Work Order ID 113907

D4541-1 BRACKET

DRAWING NO. **D4541** REV. D
SHEET 1 OF 11
TITLE **BRACKET** SCALE NTS

WORK ORDER NON-CONFORMANCE / UPDATE

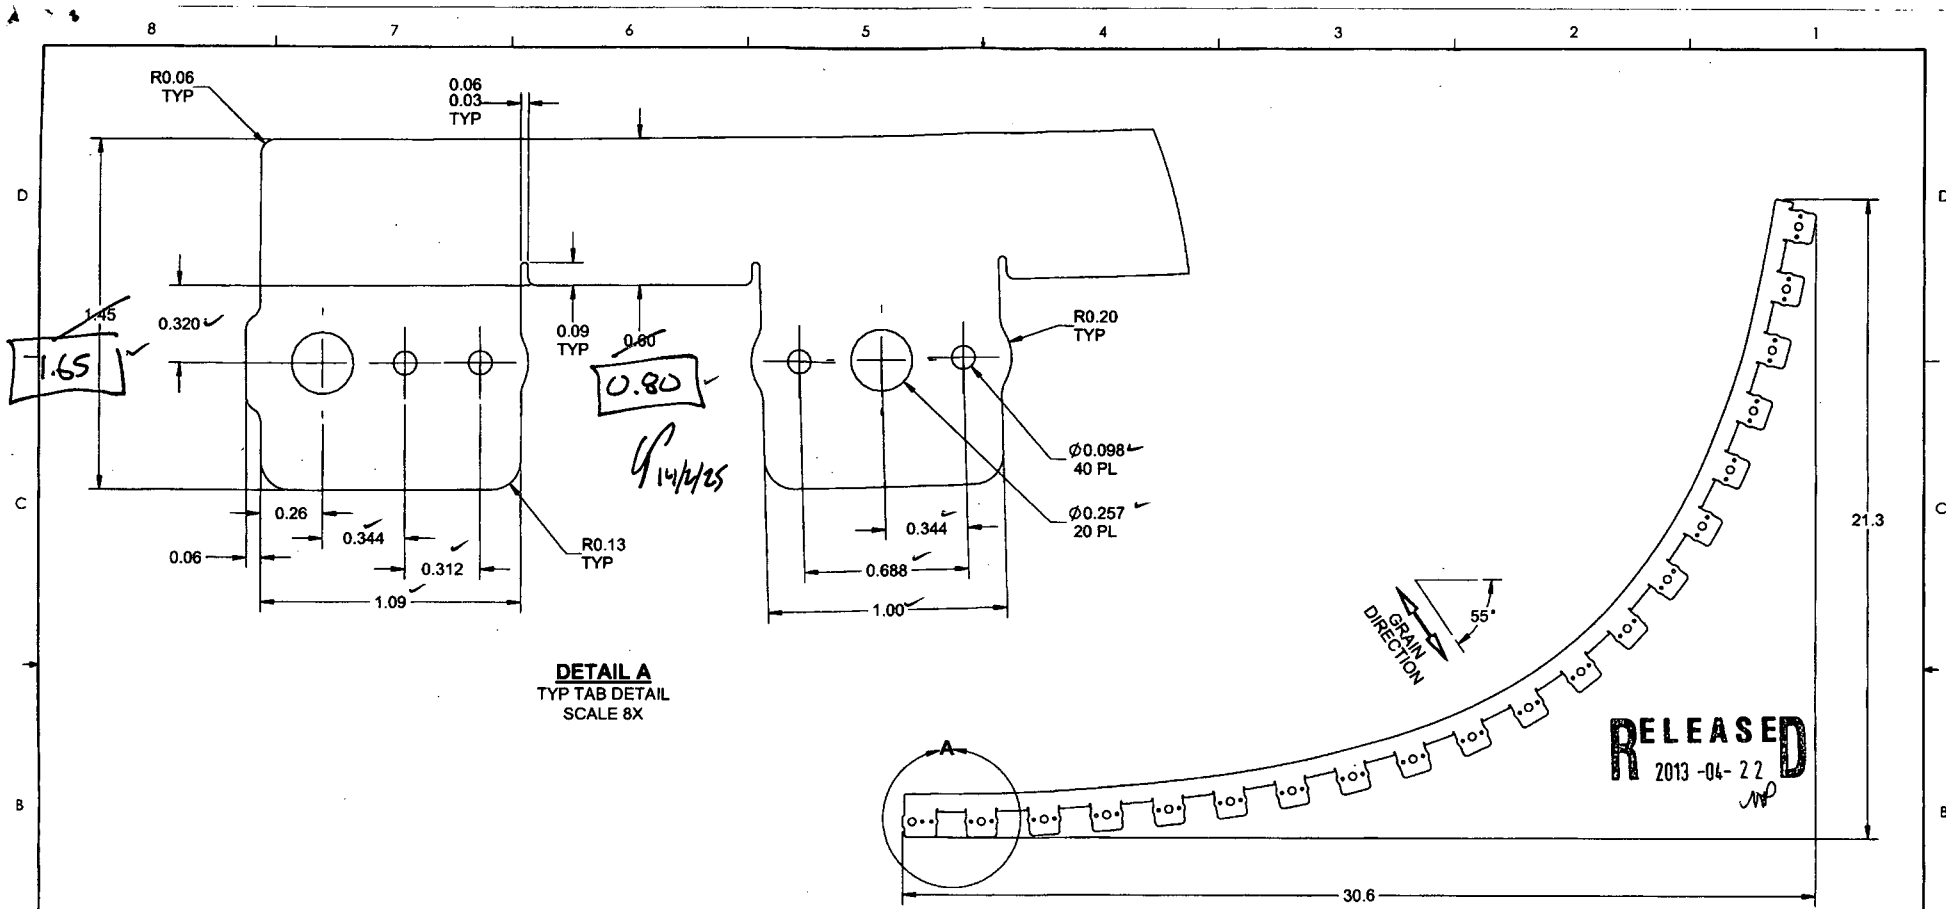
D	ADD BENT SHAPES -3/-4/-7/-8	CP	13.02.04
C	D4541-SF WAS -5; ADD -5/-6; RMV FINISH (-1/-2/-3/-5/-7); 0.70 WAS 0.60 (ZN D1-3)	CP	12.04.20
B	-5: 1.55 WAS 1.45 (ZN C4-4)	CP	12.02.01
A	NEW ISSUE	CP	12.01.09
REV.	DESCRIPTION	BY	DATE
DESIGN			
DRAWN			
CHECKED			
MFG. APPR.			
APPROVED			
DE APPR.			
DATE	13.02.04

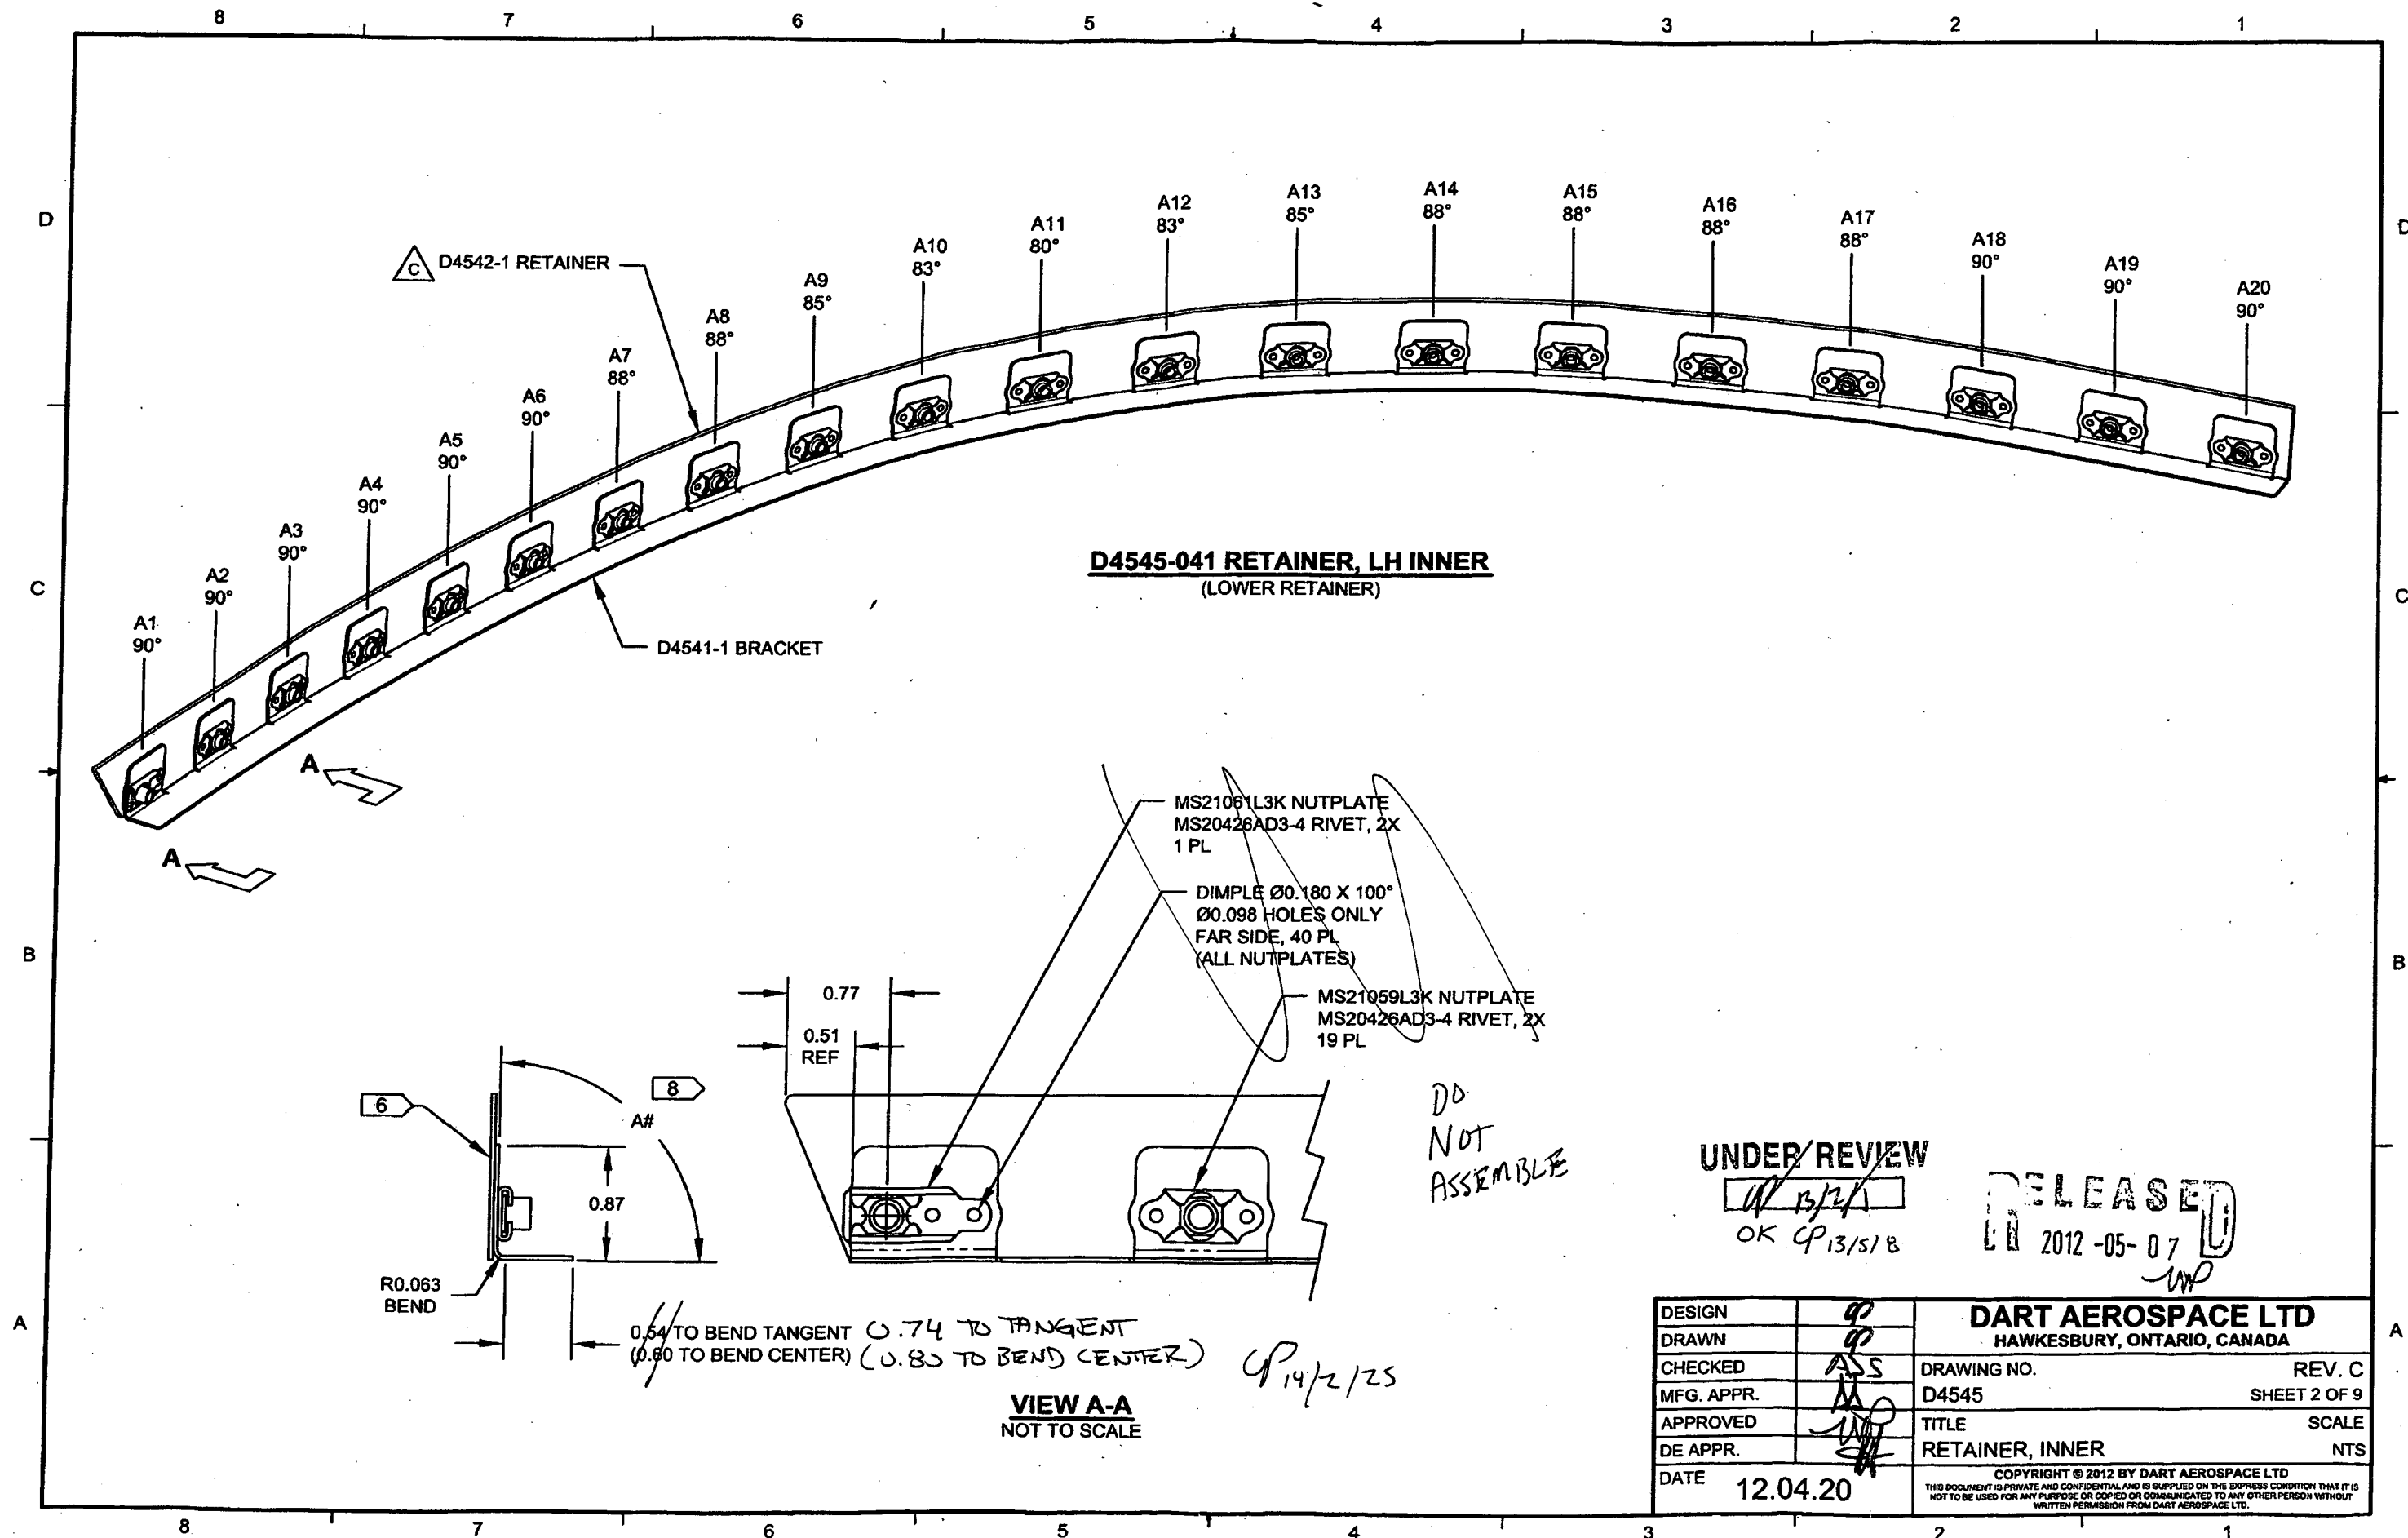
Root Cause	Date	Step	Qty	Description of work order update or non-conformance	Initial Chief Eng	Action Description	Sign & Date	Verification	QC Inspector
Design	14/2/25	100	2	CUSTOMER NEEDS CUSTOM PART TO FIT HIS AIRCRAFT.	DAS 12 9-89 14/2/25	BASE IS 0.200 WIDER TO ENSURE PROPER HOLE EDGE DISTANCE	DAS 12 9-89 14/2/25	DAS 27 9-89 14/2/27	DAS 27 9-89 14/2/27
Doc/Data									
Equip/Tooling									
Handling/Pre									
Material									
Operator									
Offset/Setup									
Process									
Supplier									
Training									
Transport					DAS 12 9-89 14/4/25	BEND TABS PER D4541 marked-up D4545 dwg attached. DO NOT ASSEMBLE	DAS 30 9-89 DAS 36 9-89 14/2/27	DAS 27 9-89 14/2/27	DAS 27 9-89 14/2/27
Unapproved
